Access Compliance Report Public Rights-of-Way (Curb Ramps)

Intersection ID: 10020275Main Street: AYRSLEY_TOWN_BVCross Street: N/ALocation:SWADA ID: ADA18105DD88Ramp Type: PerpInitial Pass/Fail: FailOverall Compliance: NoSeverity Score:22.5

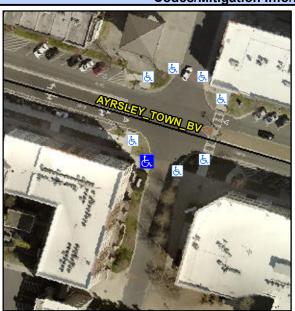
Possible Solutions:	c		
Remove & Replace Entire Ramp.			
•	N		
	N/		
	N		
	N		
	N		
Surveyor Notes:	N		
N/A	N		
	N		
	N		
	N		
PROW/ADA:	N		
Not Found, R304.5.1, R304.2.2,	N/		
R304.5.3	N		
	N		
	N

Field Measurements/Component Compliance						
Compliance Description		Data	Comp	liance Description	Data	
N/A	Ramp Length (in)	63.0	No	Ramp Slope (%)	8.7	
No	Ramp Width (in)	45.0	No	Ramp XSlope (%)	3.4	
N/A	Flare Type LT	N/A	N/A	Flare Type RT	N/A	
N/A	Flare Slope LT (%)	N/A	N/A	Flare Slope RT (%)	N/A	
N/A	Flare Traversable LT?	N/A	N/A	Flare Traversable RT?	N/A	
N/A	Landing Length (in)	N/A	N/A	DWS Provided?	N/A	
N/A	Landing Width (in)	N/A	N/A	DWS Contrast?	N/A	
N/A	Landing Slope (%)	N/A	N/A	DWS Length (in)	N/A	
N/A	Landing X Slope (%)	N/A	N/A	DWS Full Width?	N/A	
N/A	Landing Curb? (Y/N)	N/A	N/A	DWS Offset (in)	N/A	
N/A	Shared Landing?	N/A				
N/A	Gutter Ponding?	N/A	N/A	Gutter Slope (%)	N/A	
N/A	Gutter Lip Ht (in)	N/A	N/A	Gutter X Slope (%)	N/A	
N/A	Painted X Walk1?	No	N/A	Painted X Walk2?	N/A	
	X Walk 1 Direction	To E		X Walk 2 Direction	N/A	
N/A	X Walk 1 Width (in)	N/A	N/A	X Walk 2 Width (in)	N/A	
	X Walk 1 Slope (%)	3.8		X Walk 2 Slope (%)	N/A
